My Interim Objection letter to planning application HGY/2023/1199

RE: 31A Riverside Road, London, N15 6DA

1. The Cover Note is provided in support of a planning application for the 'Demolition of existing single storey dwelling and construction of two storey plus basement to an end of terrace property' at 31A Riverside Road, London, N15 6DA.

Figure 5.1: Basement Floor Daylight Factor Plot

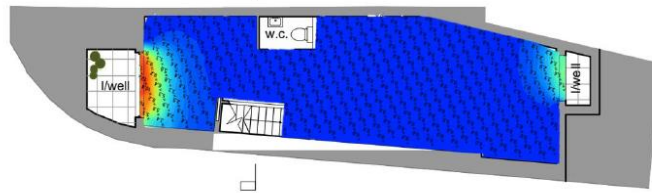
- This is the latest comparison of Light and Layout from the New application above (HGY/2023/1199) and below we are outlining and comparing the layout with the old layout of the previous application (HGY/2021/1470) that was refused by your department and again on appeal numerous times.

Thus, there is naturally a lack of light as the previous space is subdivided by walls and doors, cupboard and w.c. compartments and the utility area at the rear. The applicant is now attempting to compare the new scheme as outline in the plan in paragraph 3 above, (HGY/2023/1199) where the basement space is a large open space and is void of compartment space but now includes a single room indicated as "BATH and W.C" area.

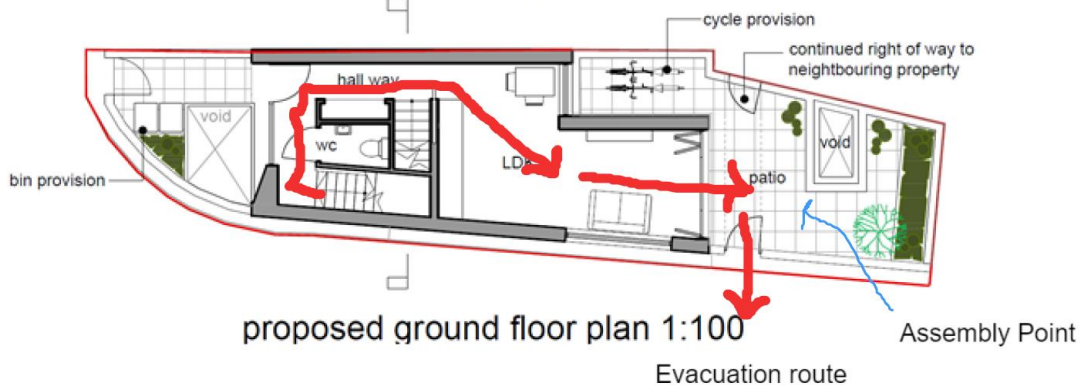
- a. How is this going to work in accordance with the application and stipulation for bins for the 4 + occupants in the 2-bedroom house?

- b. And now there is another application for an empty warehouse looking basement, with lightwells (front one takes up the bin area) but this time the bathroom space and location has changed and now stipulates a BATH and WC, with nothing else there. Who is going to believe this nonsense when it is clear that the space has to be used for living accommodation as per all the other previous failed basement applications?
